MONTGOMERY COUNTY HISTORIC PRESERVATION COMMISSION
STAFF REPORT

Address:	8000 Hampden Lane, Bethesda	Meeting Date:	2/7/2024
Resource:	Contributing Resource (Greenwich Forest Historic District)	Report Date:	1/31/2024
Applicant:	Chuen-Yen Lau & Adam Sherwat	Public Notice:	1/24/2024
Review:	HAWP	Tax Credit:	n/a
Permit No.:	1029531 REVISION	Staff:	Dan Bruechert
Proposal:	Revision to previously approved HAWP for alterations to previously approved garage

PROPOSAL

A002

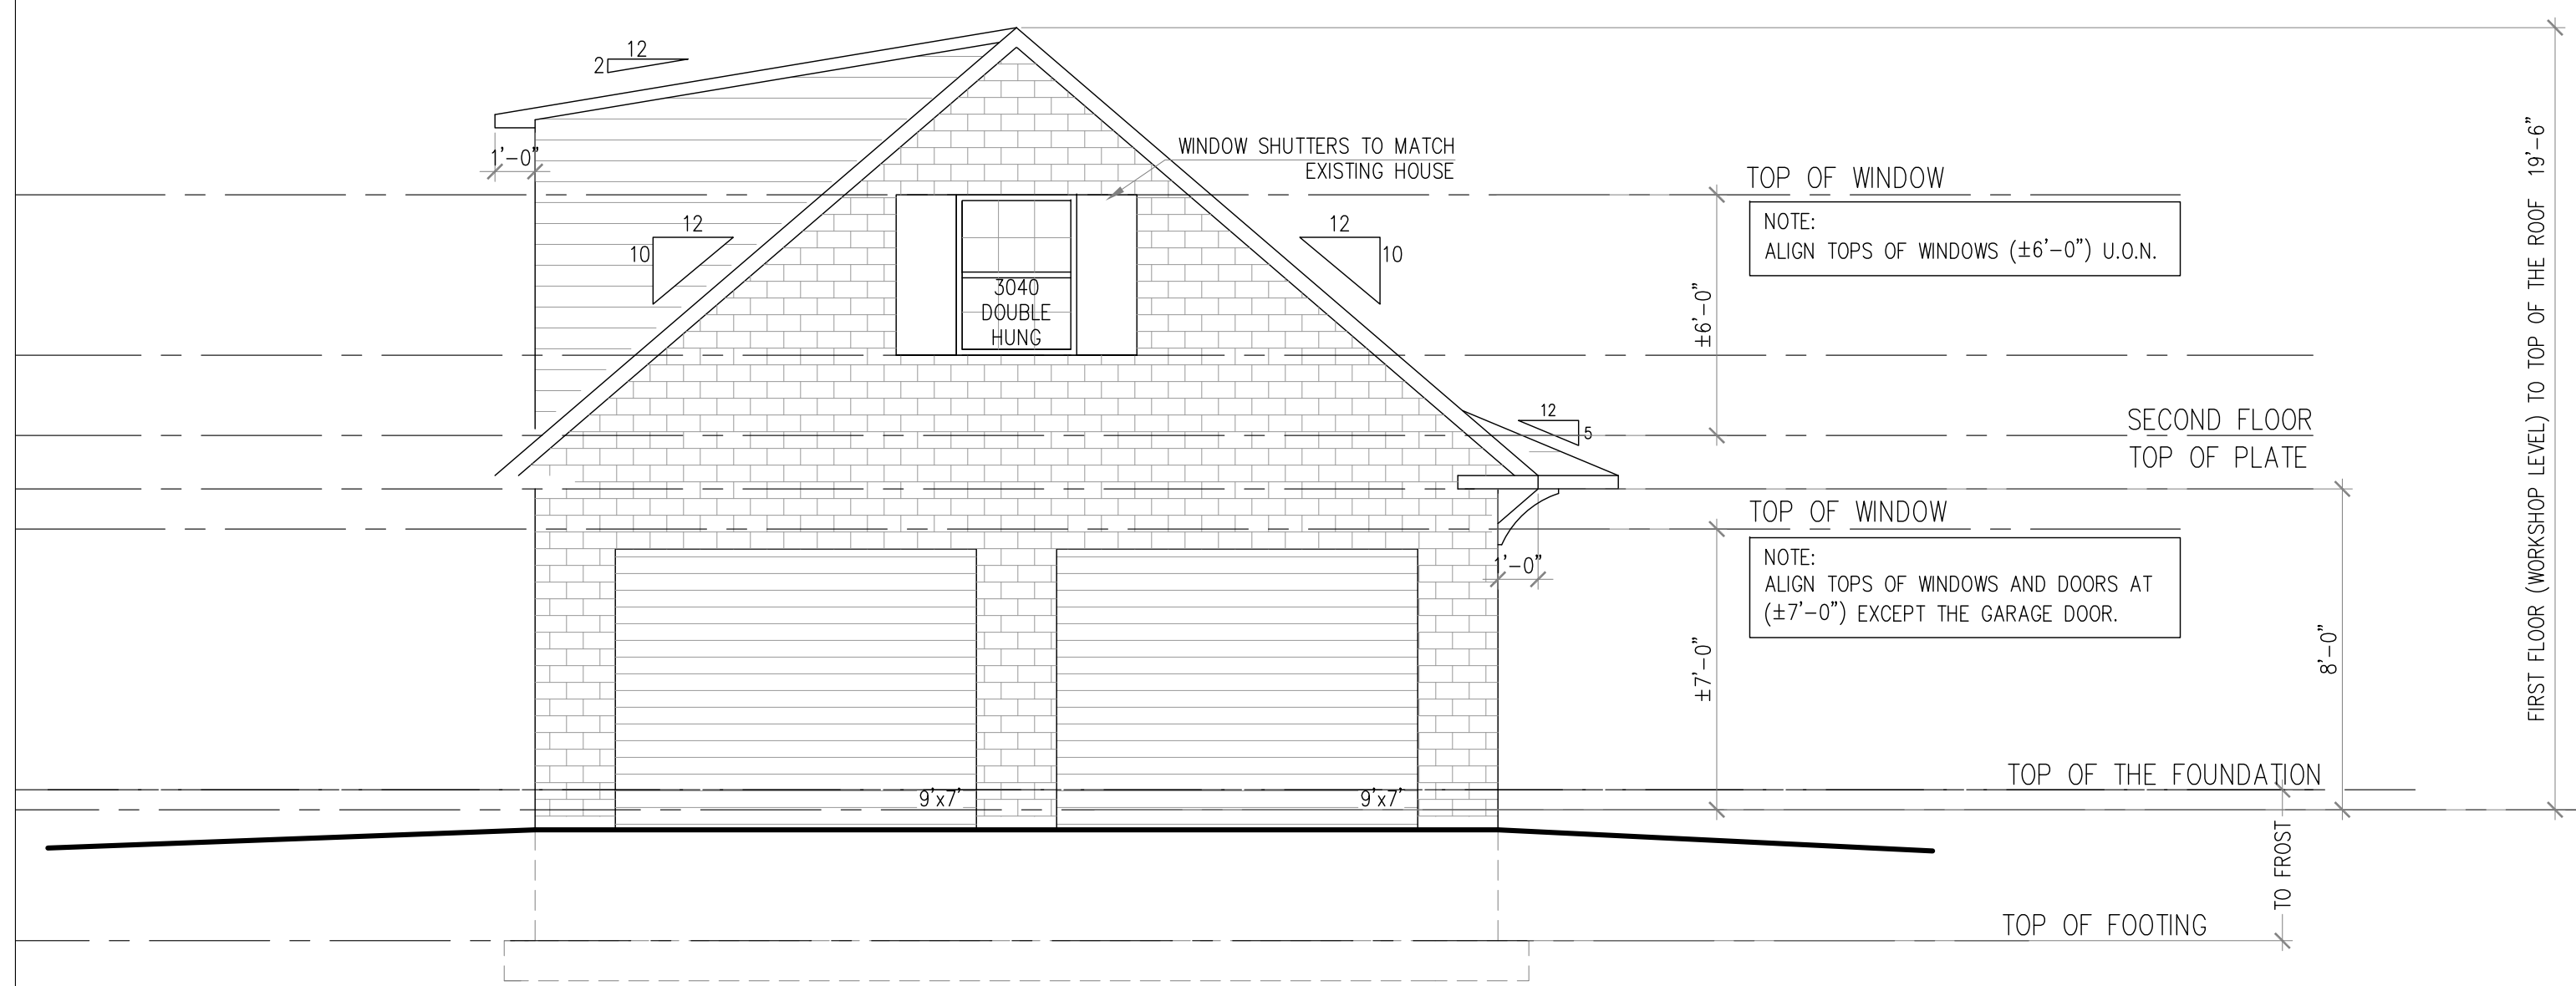
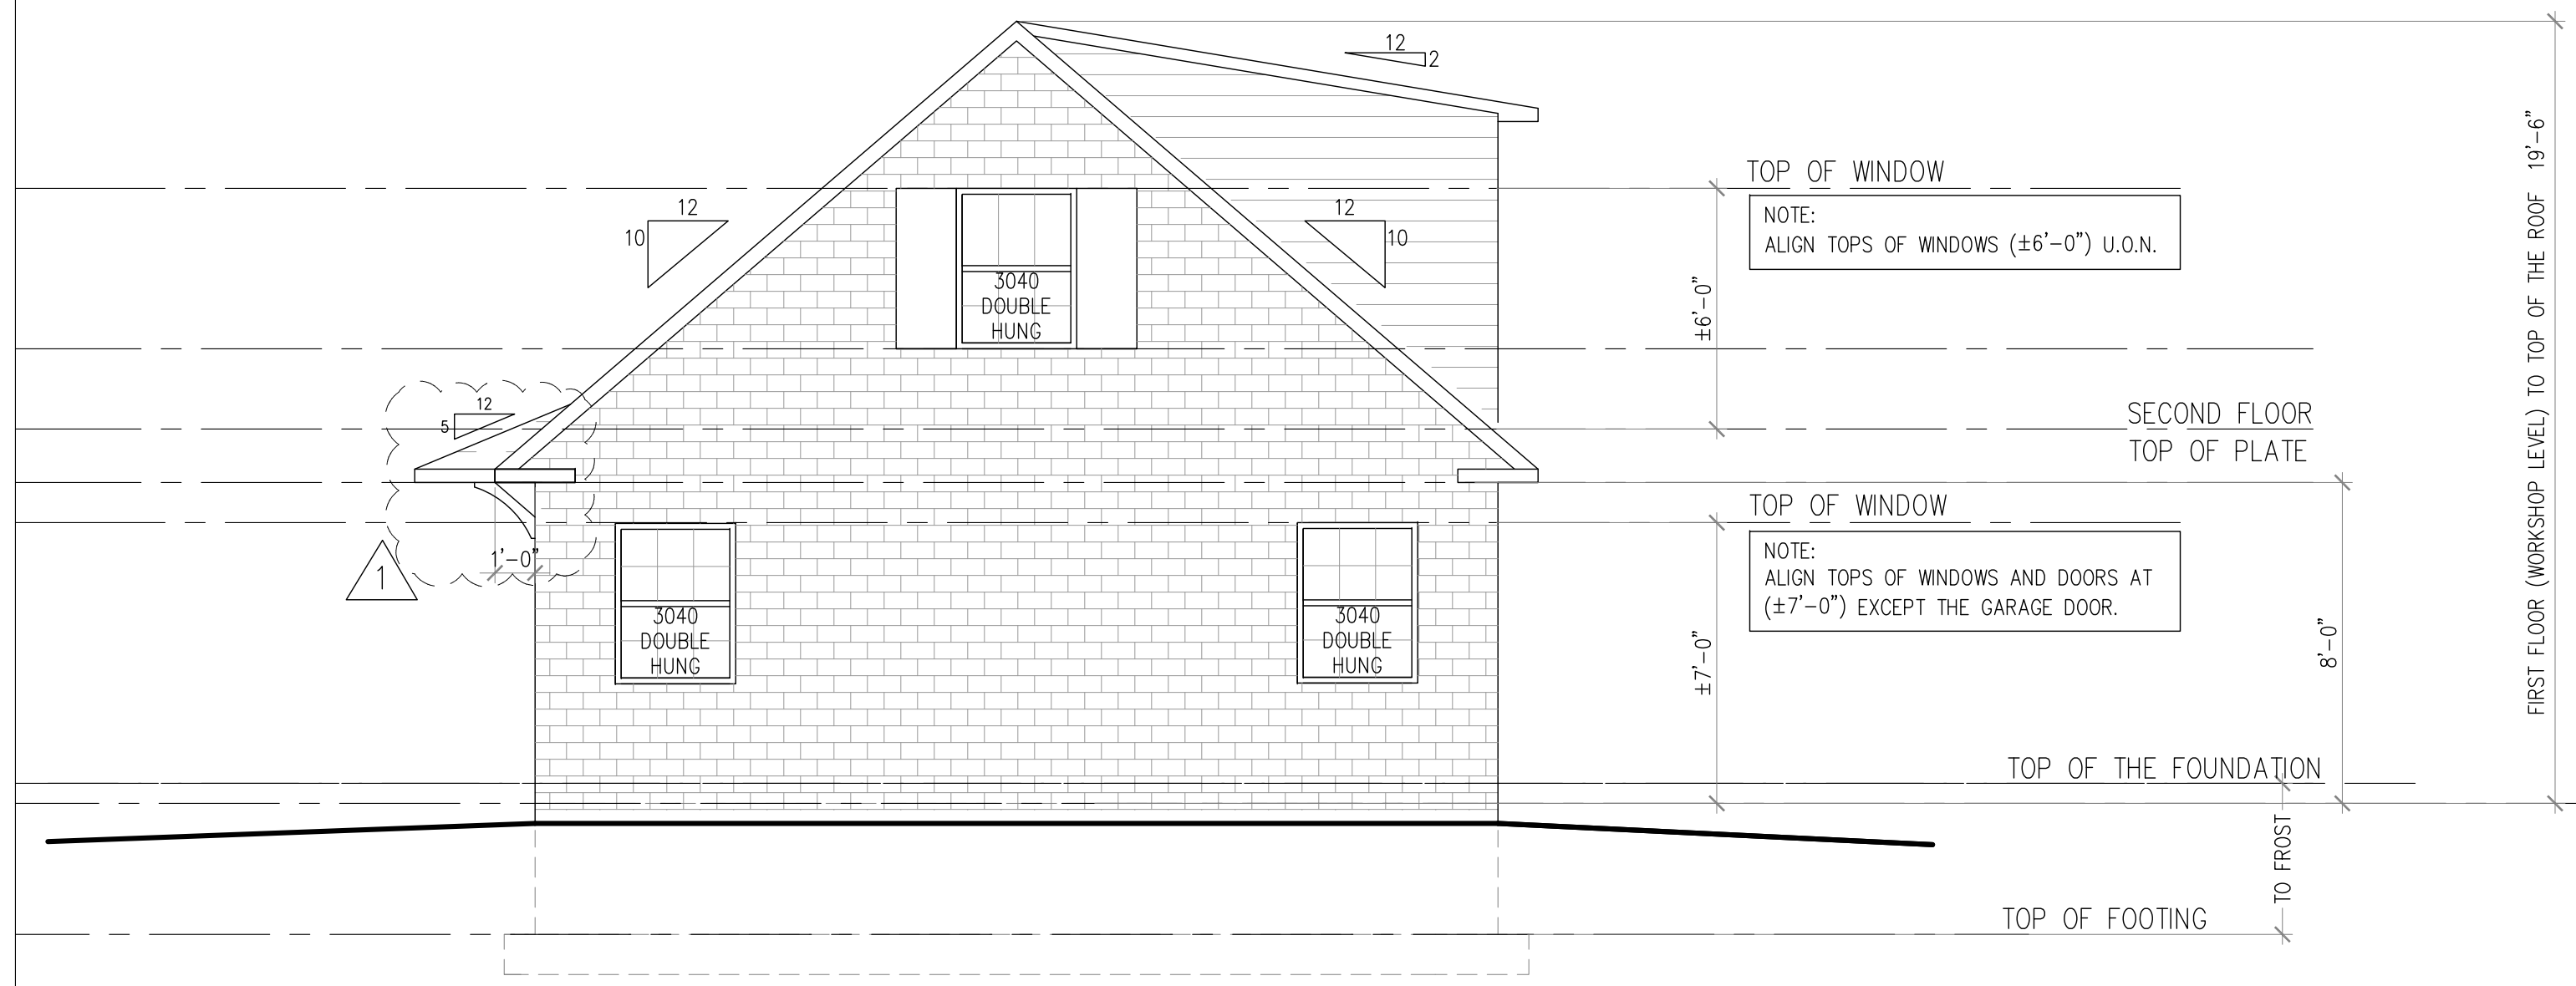
1	Brackets on each side of the door at the workshop shown on the right elevation.
---	---
